MOUCHAK KNIT COMPOSITE LTD. (New Building)

Mouchak, Kaliakoir, Gazipur
(24.0231N, 90.2889E)
12 April 2022

1. New Building: Six storied RC building with a partial basement.

Stressed column/foundation in layout

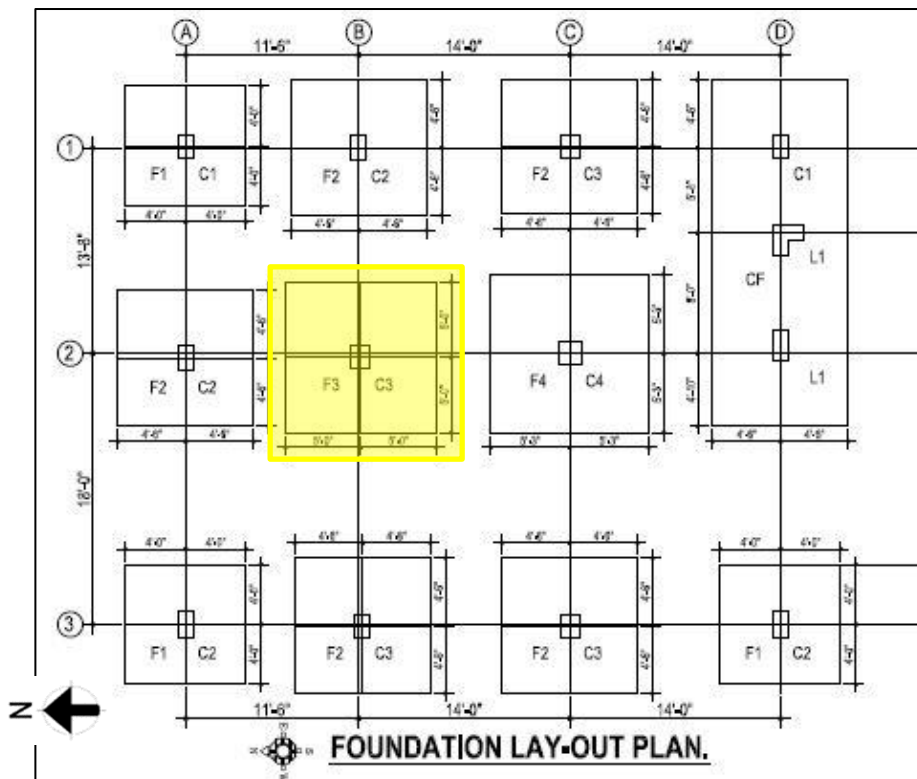
**Stress in column and foundation exceeds
normal design limit**

Cursory calculation indicates that stress in column and foundation exceeds normal design limit at marked locations considering the floor live load as per prepared live load plan (3 kPa for typical floor, 5 kPa for stair and 1.5 kPa for roof), minimum concrete strength based on aggregate type and allowable soil bearing capacity 13.45 Ton/m² (132 kPa). Building engineer is required to review the design, loads, column and foundation stresses for the area identified above. Verify in-situ concrete strength by taking 4-100 mm diameter core from column (lower tier of the building).

Brick chips found as aggregate in columns

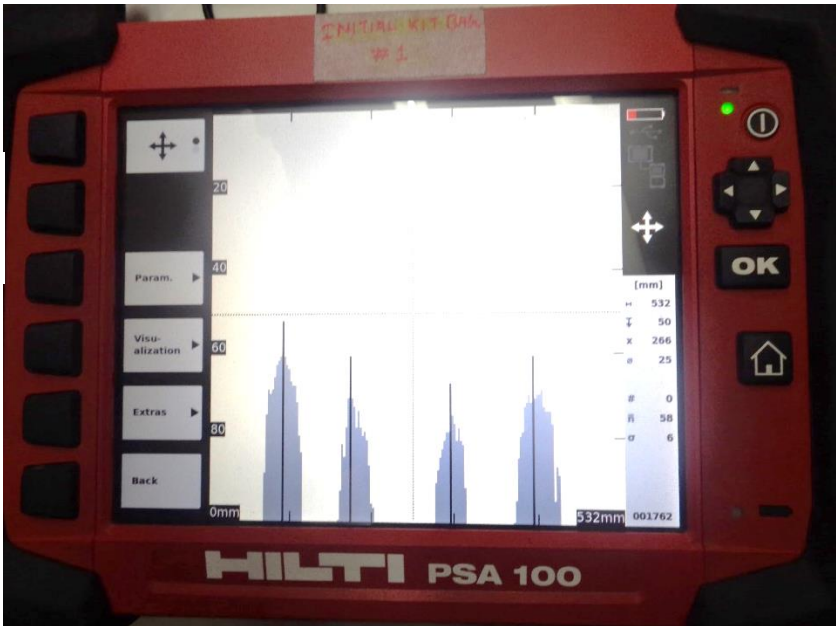
Strength of concrete and rebar considered in Engineering Assessment report was 3500 psi (24.13 MPa) and 500 MPa. Stone chips mentioned as aggregate.

Strength of concrete and rebar considered in Engineering Assessment test report as 24.13 MPa and 500 MPa without any test report. Also, aggregate type mentioned as stone chips in Engineering Assessment but physically found as brick chips in columns.

Ferro scan report shows 4 rebar at each side of column C-4 at 3rd floor

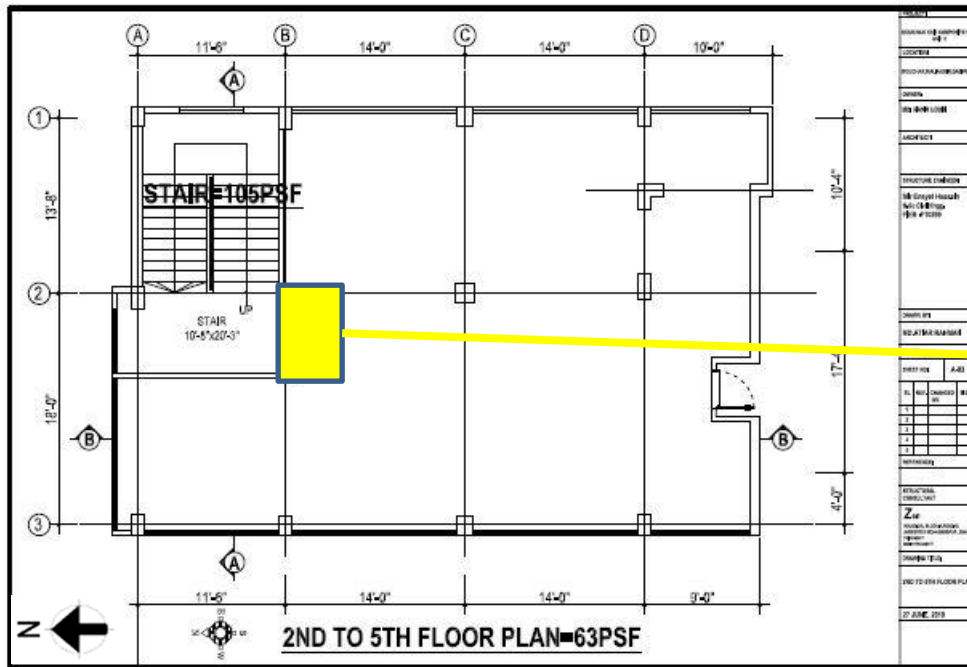
5 rebar shown for each side above 1st floor for C-4 Column

5 rebar shown for each side above 1st floor for column C-4 but Ferro scan shows 4 rebar at each side of column C-4 at 3rd floor (12 rebar counted instead of 16). Building engineer is required to resurvey the whole structure and update as-built drawing accordingly.

Basement plan not shown in drawing

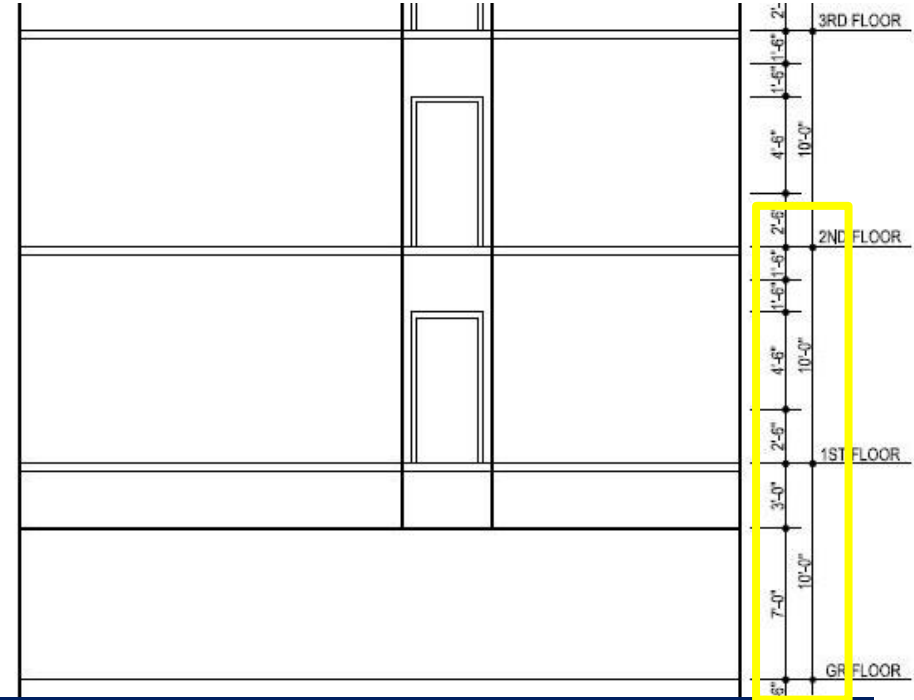
Plan of basement level was not shown in drawing. Building engineer is required to survey the whole structure and update as-built drawing accordingly.
